REMEDICATION SYSTEM EVALUATION

GREEN REMEDIATION EVALUATION

**SHEPLEY'S HILL LANDFILL  
DEVENS, MASSACHUSETTS**

Report of the Remediation System Evaluation  
Site Visit Conducted at the Shepley's Hill Landfill Site  
April 8, 2009

5-9

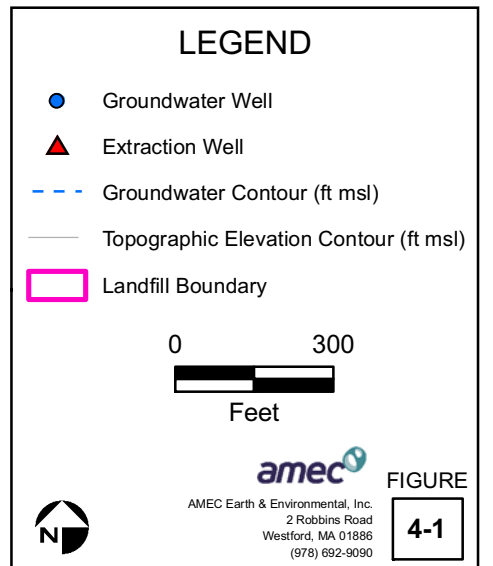
- The use of reverse particle tracking as illustrated on Figure 5-9 of the AMEC report is not ideal for illustrating the three-dimensional capture zone. A more effective approach would be to release particles in each cell within the area of interest at a specified depth (such as the middle of layer 1) and track them forward. These particle locations can then be symbolized based on where they end up (i.e., a different symbol for each recovery well, the pond, the creek, etc.). Then that same analysis can be preformed by starting the particles at different elevations (e.g., bottom of layer 1, and middle of layer 2, and perhaps even the upper portion of layer 3 which represents bedrock). This is important to illustrate how similar or different the zone of capture is with respect to depth (which may be complex based on the fact that the extraction wells are only screened in layer 2 and there is vertical anisotropy). This approach would more accurately illustrate the three-dimensionality of the capture zone.

Figure 5-9 from the December 2008 Supplemental Report (see Attachment A of this report) indicates substantial groundwater flow from recharge on Shepley's Hill migrating through the landfill and then either to the extraction network, Plow Shop Pond, or downgradient to Nonacoicus Brook. It is assumed that a revised model would provide similar results in that regard. If the amount of water discharging from Shepley's Hill through the landfill is reduced then less groundwater would flow through the landfill, and the capture zone could widen substantially. This could be accomplished by pumping clean recharge water from Shepley's Hill before it flows through the landfill and either reinjecting it downgradient of the extraction system, discharging it to Plow Shop Pond, or discharging it to Nonacoicus Brook. It should be noted that recharge from the hill may flow primarily through the fractured rock and discharge upward to overburden beneath the landfill cap. In this event, interception of the recharge from the hill would require a line of *bedrock* wells along the east side of the hill (i.e., west side of the landfill). Because Shepley's Hill and the associated water table in this location is higher than the described discharge points, much of this flow could be accomplished by gravity to avoid the electrical costs and environmental footprint of
